YARRA CITY COUNCIL

Internal Development Approvals Committee

Item		Page	Rec. Page
1.1	PLN18/0172 - 622-642 Nicholson Street Fitzroy North - The construction of a ten storey building plus three basement levels and a roof top terrace, the use of the land as an office, medical centre, supermarket and a bottle shop, the sale of liquor for consumption off the premises, a reduction in the car parking requirement and alterations to the access to a road in a Road Zone, Category 1 by removing and altering crossovers to Nicholson Street.	5	43

1.1 PLN18/0172 - 622-642 Nicholson Street Fitzroy North - The construction of a ten storey building plus three basement levels and a roof top terrace, the use of the land as an office, medical centre, supermarket and a bottle shop, the sale of liquor for consumption off the premises, a reduction in the car parking requirement and alterations to the access to a road in a Road Zone, Category 1 by removing and altering crossovers to Nicholson Street.

Attachment 4 - PLN18/0172 - 622-642 Nicholson Street Fitzroy North - Sketch Plans

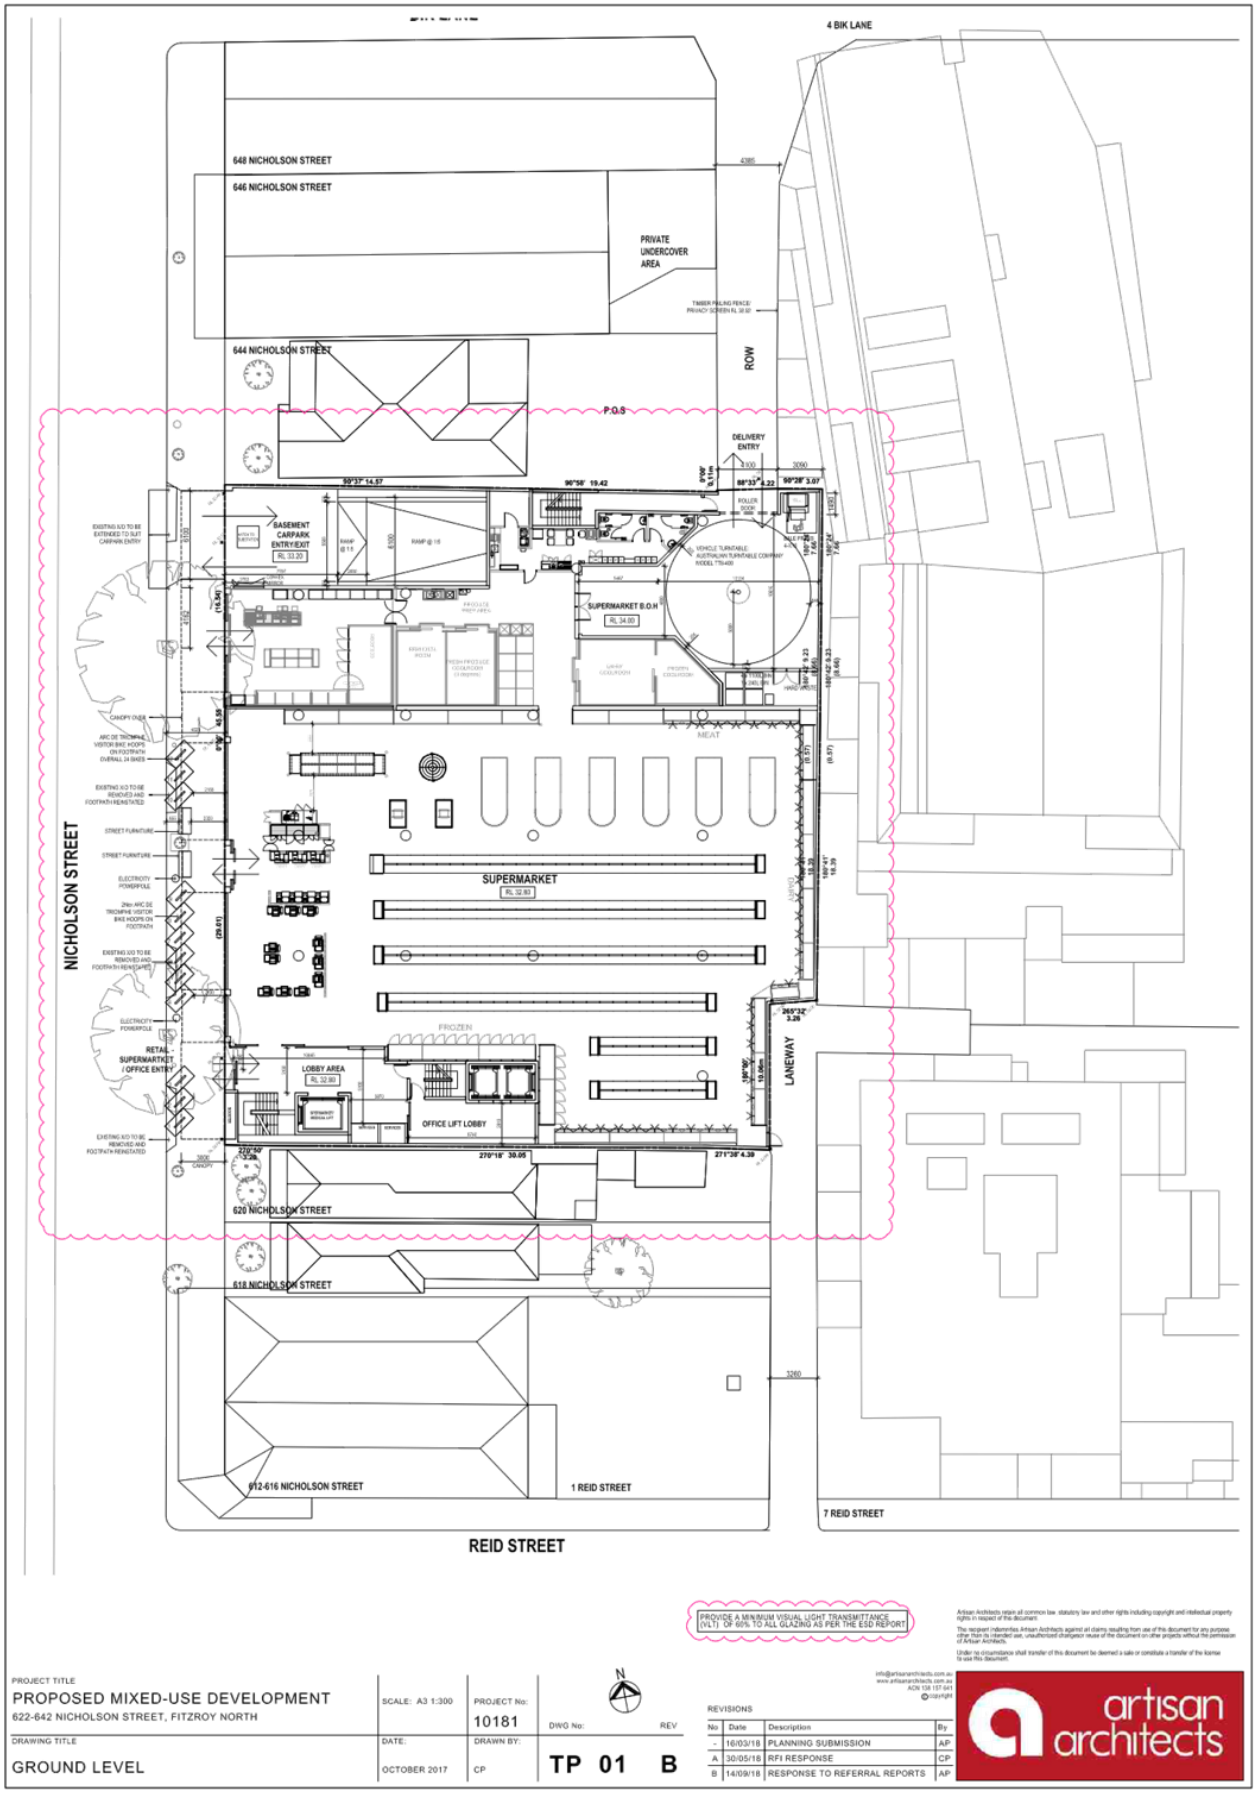
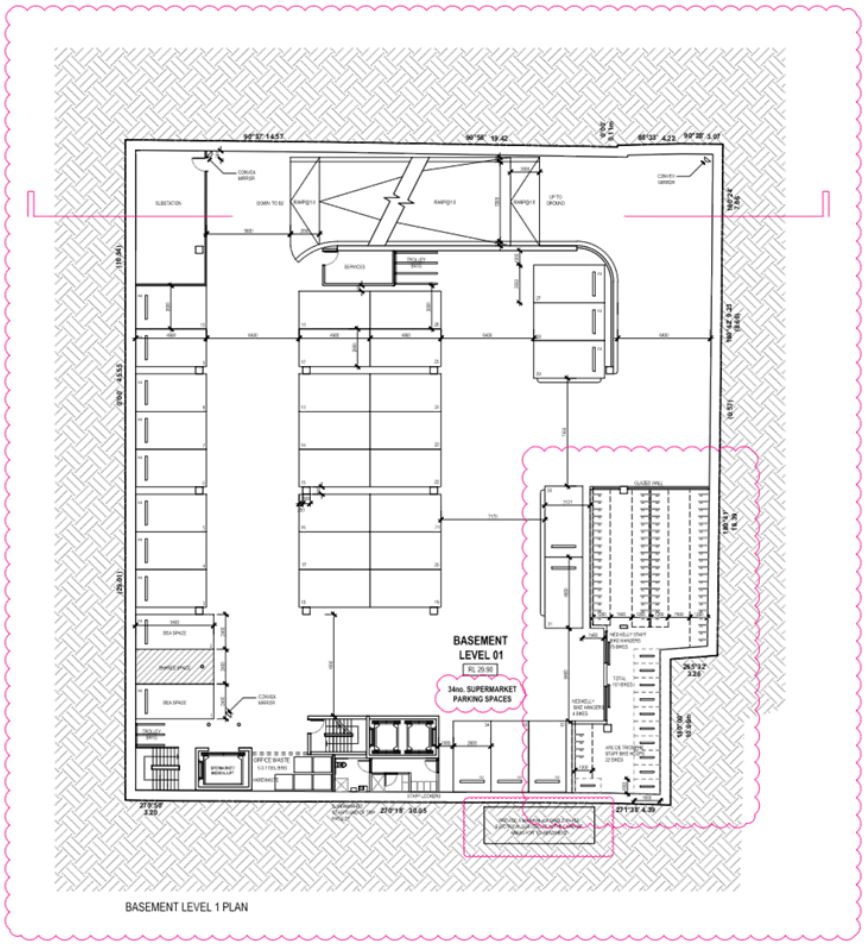
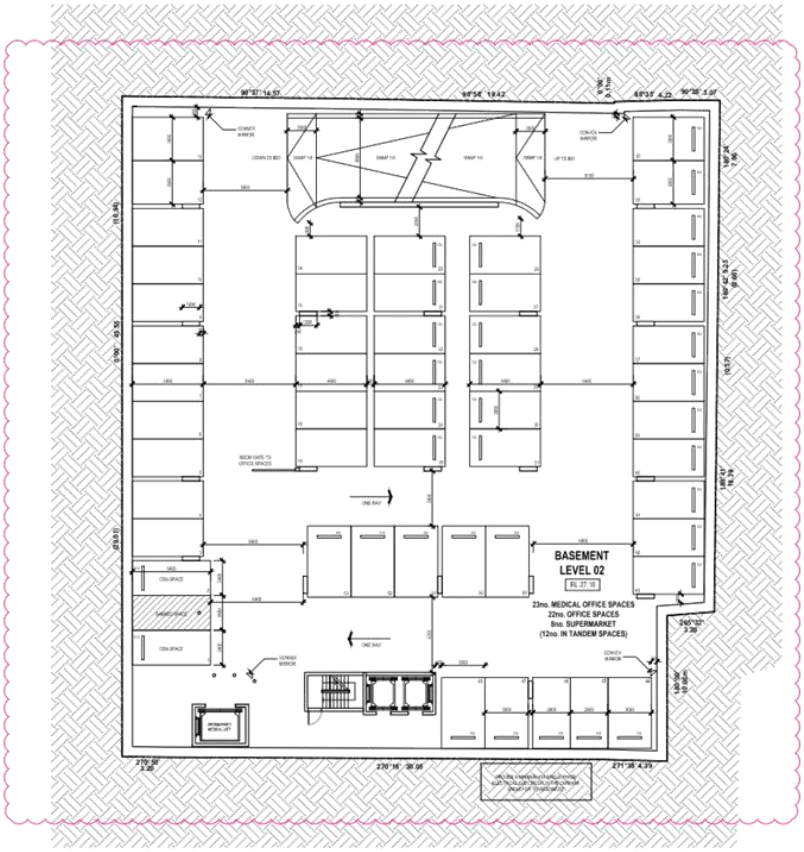
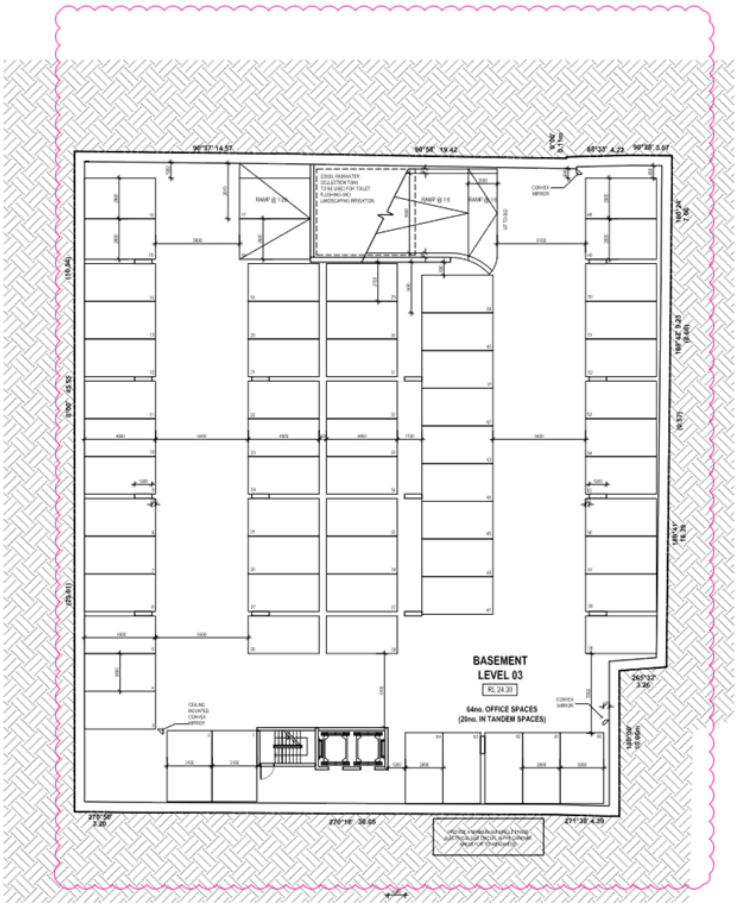
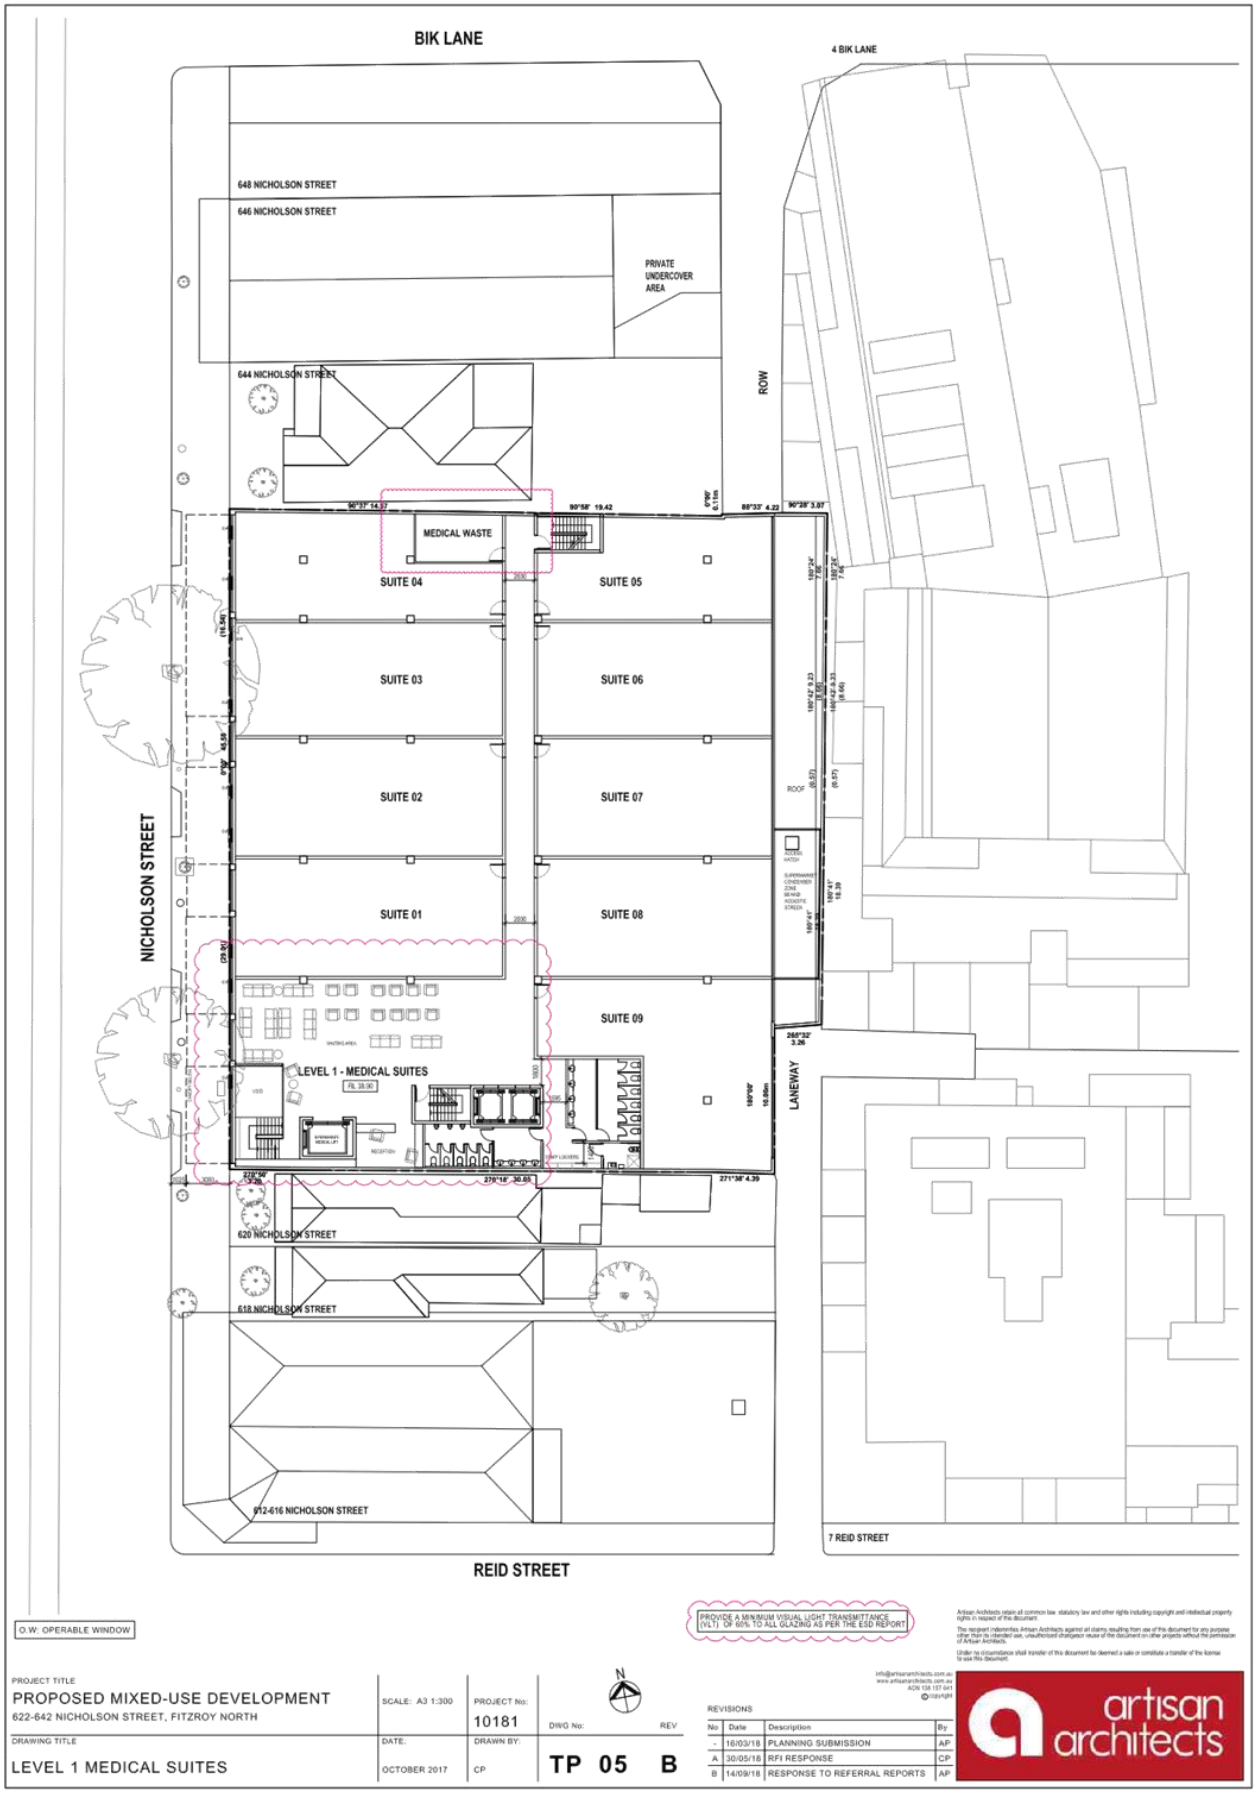
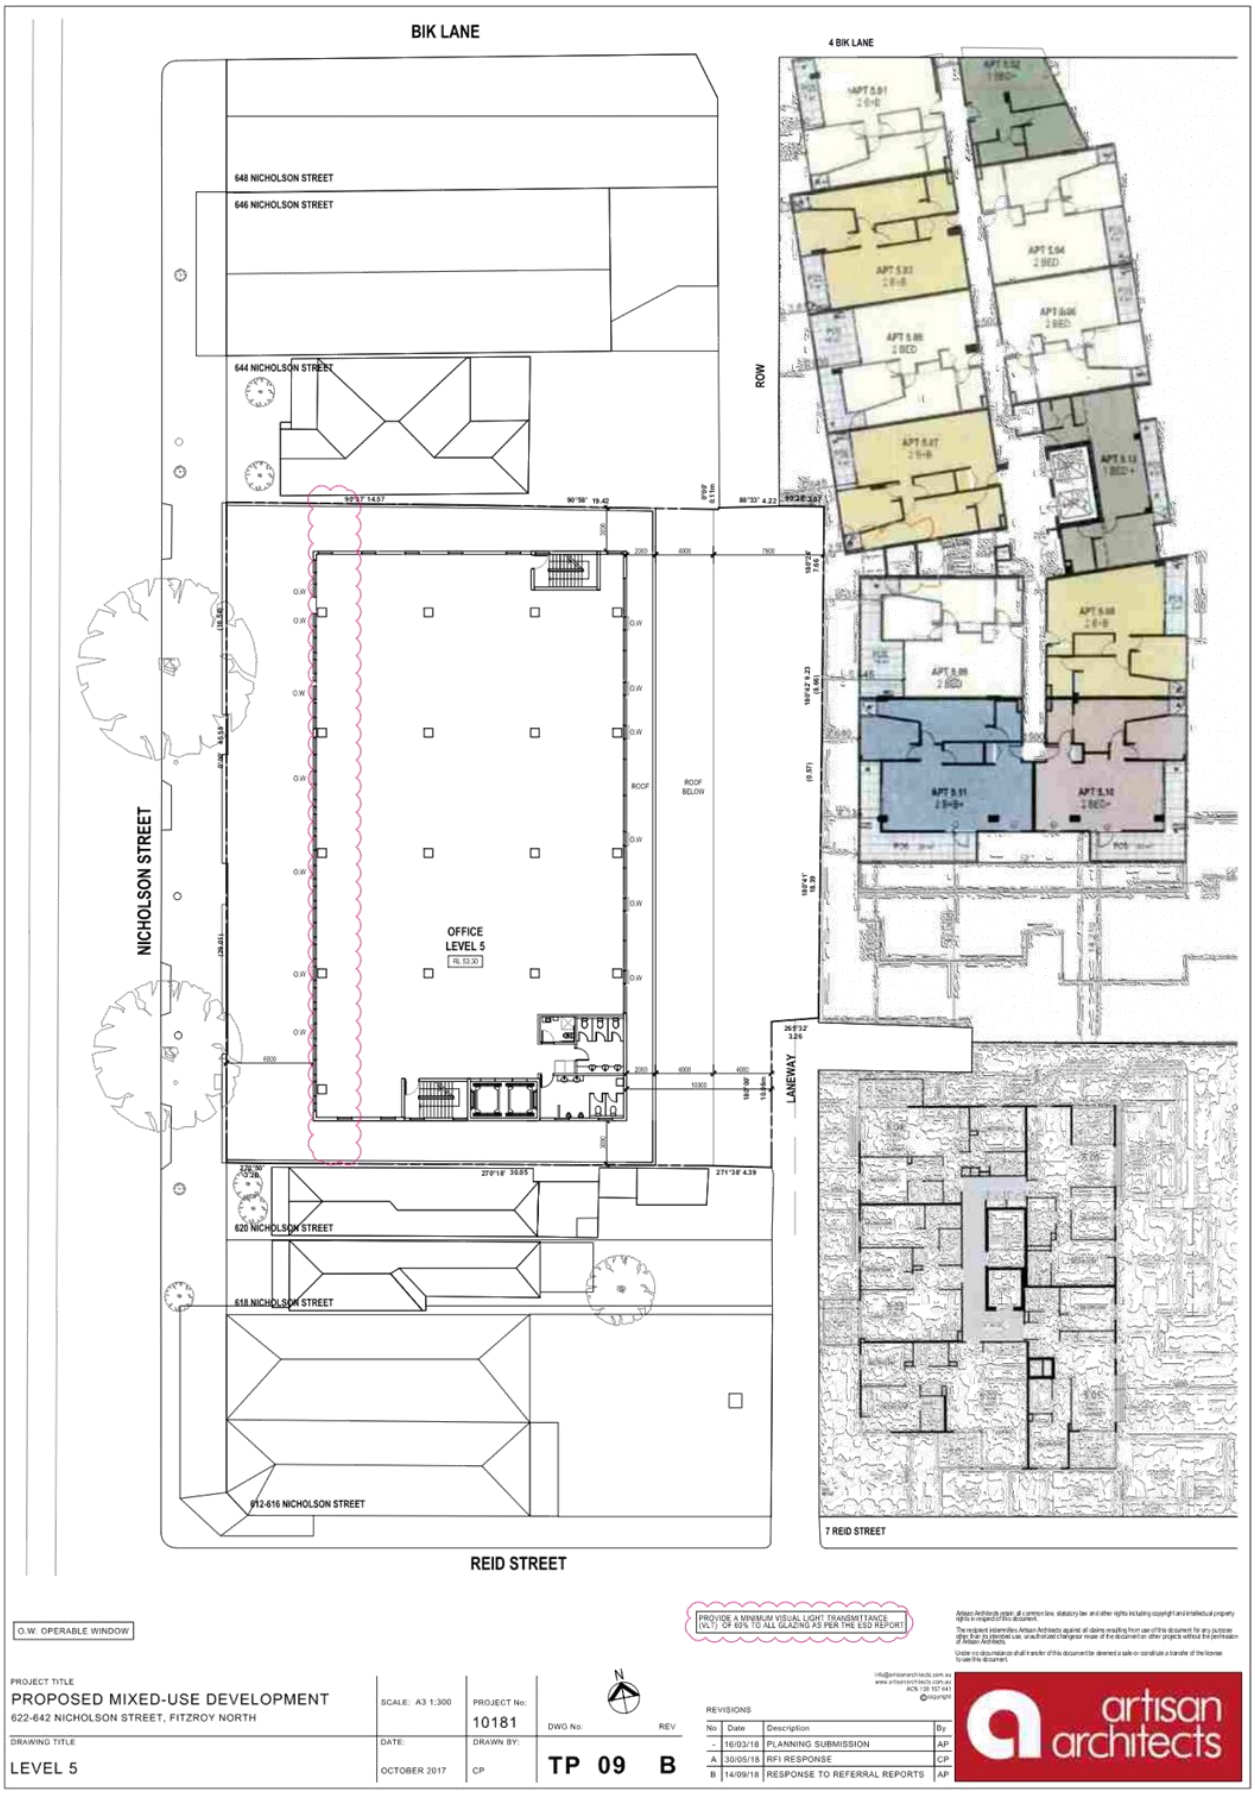
14. In response to issues raised in the submitted objections, as well as issues raised by Council officers and in referral comments, a set of sketch plans prepared by Artisan Architects and dated 14 September 2018 (Attachment 4) were submitted to Council after the advertising period. The sketch plans show the following changes to the proposed development as depicted in the advertised plans:
